LAKE ROAD PLAZA ROOF CONDITION REPORT

Prepared by:
William St Croix
Healthy Home Inspections CFL, LLC
hicfl@ive.com
321-527-8480

EXECUTIVE SUMMARY
7780 & 7790 Lake Rd Orlando, FL 32821

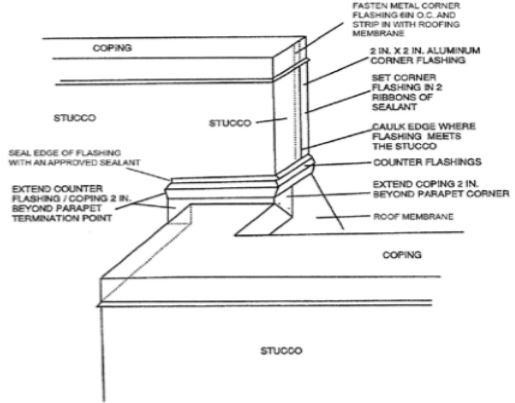
<p>Recommend installation of lock tight washers. The sealant will dry, crack, and shrink. This could potentially cause moisture intrusion into the roof assembly. Further evaluation by a licensed HVAC contractor.</p>
	<p>Showing electrical clamp support attached with fasteners through the base flashing. This can void Firestone's warranty. Corrective action is required to eliminate penetration.</p>
	<p>The flex cable and copper tubing from the HVAC condenser units entering the vent hood shall have a drip line to prevent moisture entry into the roof assembly.</p>

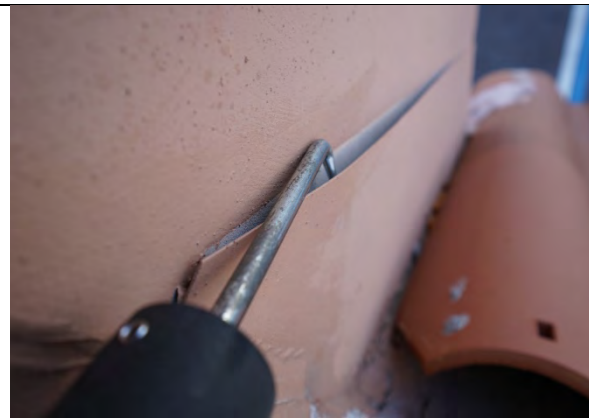
<p>Recommend installing metal counter flashing over the louver flange to prevent moisture intrusion.</p>
	<p>General view of stucco accent band.</p>
	<p>Voids at miters should be sealed with appropriate sealant to prevent moisture intrusion into the wall assembly and the roof assembly.</p>

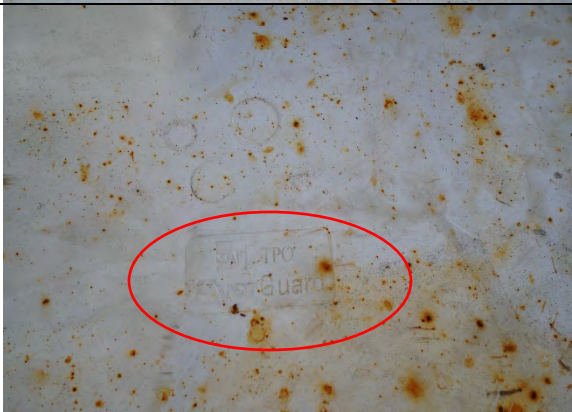
Plans, specifications and contract require coping metal to be secured 12"-inch o.c. This was not in compliance.

Metal coping cap not in compliance with specifications and contract. Coping was not sloped $\frac{1}{2}$ "-inch per foot towards the inside of the roof.

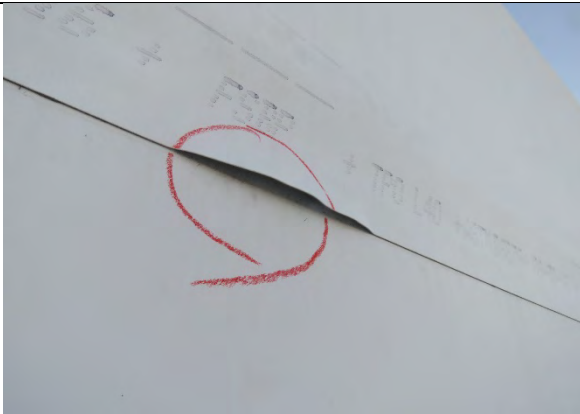
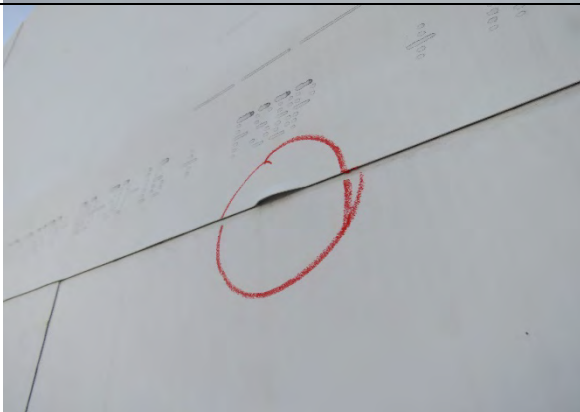
Showing open lap seam underneath counterflashing.

Showing open lap seam at outside corner patch at base of goose neck vent.

Missing T-patch at base of goose neck per manufacturers requirements.

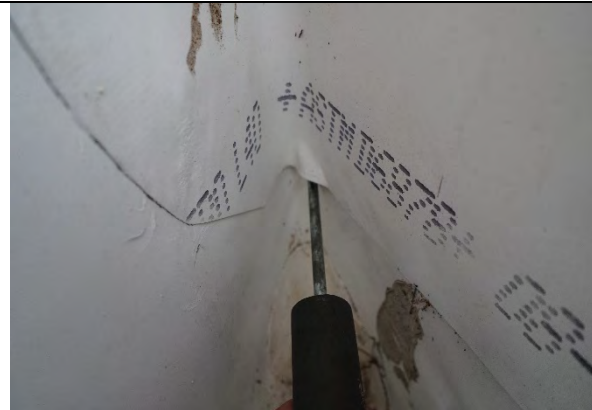
<p>Recommend adding edge cut sealant per manufacturer's requirements. This condition was observed at many locations and needs to be sealed everywhere the membrane has a cut edge.</p>
	<p>Open laps seams in corner wall/roof connection at right rear elevation for building (2) above Quest Diagnostics.</p>
	<p>Open laps seams in corner wall/roof connection at right rear elevation for building (2) above Quest Diagnostics.</p> <p>This most likely appears to be the location of leak above Quest Diagnostics.</p>

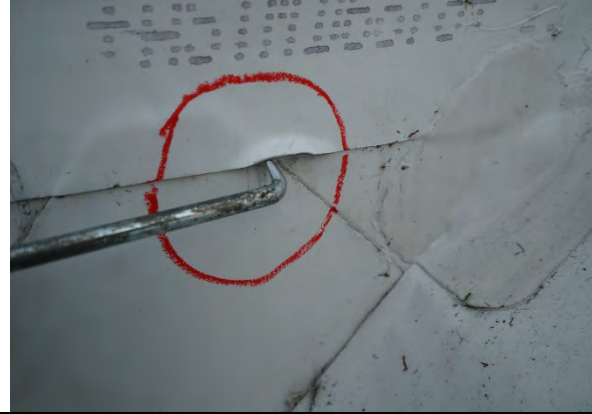
<p>Walk pads not correctly welded per manufacturer's requirements.</p>
	<p>Showing open lap seams in roof membrane at base of RTU's</p>
	<p>Showing open lap seam at roof tower exterior wall/parapet wall connection. This condition can potentially allow moisture entry into both the wall and roof assemblies</p>

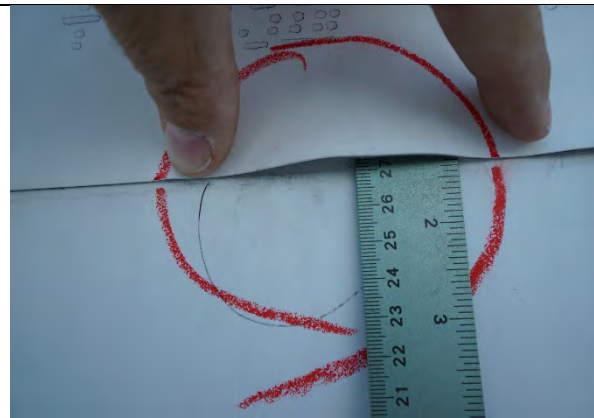
<p>Missing T-patches at base of vent hood and other location were observed. Manufacturer requires this.</p>
	<p>Open lap seams at inside corner of parapet wall.</p>
	<p>Showing a puncture to the surface roof membrane. Corrective action required to prevent water leaking beneath membrane and into the roof assembly.</p>

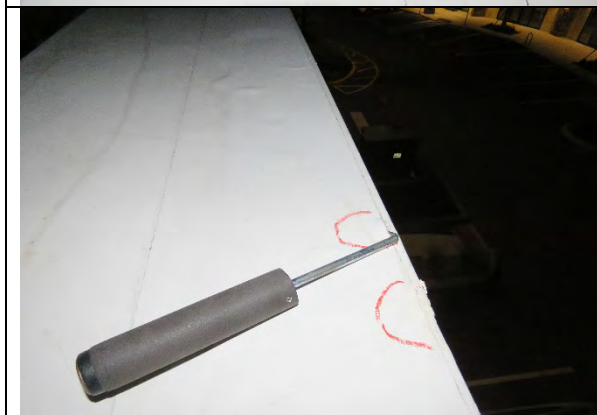
<p>Open lap seams at scuppers. This scupper was located above Quest Diagnostic where leaks were reported.</p> <p>The contractor made several attempts to repair leak. Infrared thermography and a capacitance moisture scans identified elevated moisture levels. A visible inspection was made at the interior sealing where staining was visible. Recommend further evaluation.</p>
	<p>Open lap seams at parapet wall.</p> <p>At many locations found welds not consistent with the 1.5"-inch weld per manufacturer's specifications.</p>
	<p>Open lap seams were found along parapet walls, perimeters of scuppers, on top of parapet walls and roof membrane,</p>

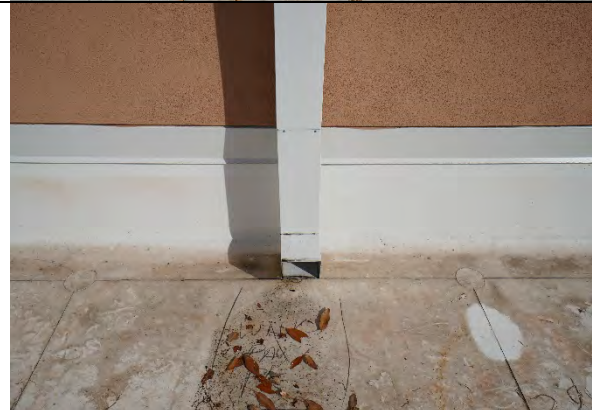
Open laps seams observed at roof membrane close to parapet wall.

Open laps at top of parapet wall. This condition will allow moisture to leak beneath membrane and potentially leak into the roof assembly.

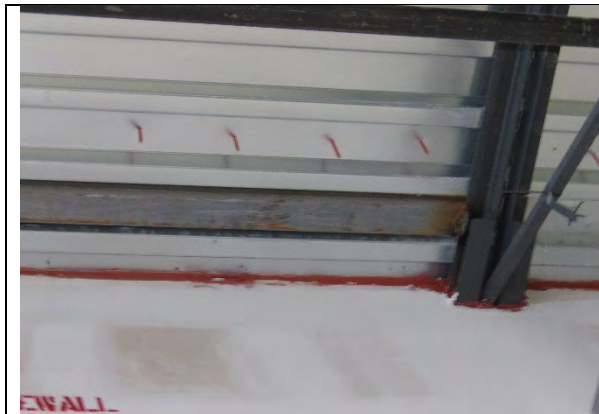
Showing rust on steel trusses under the metal roof deck indicates roof leaks.
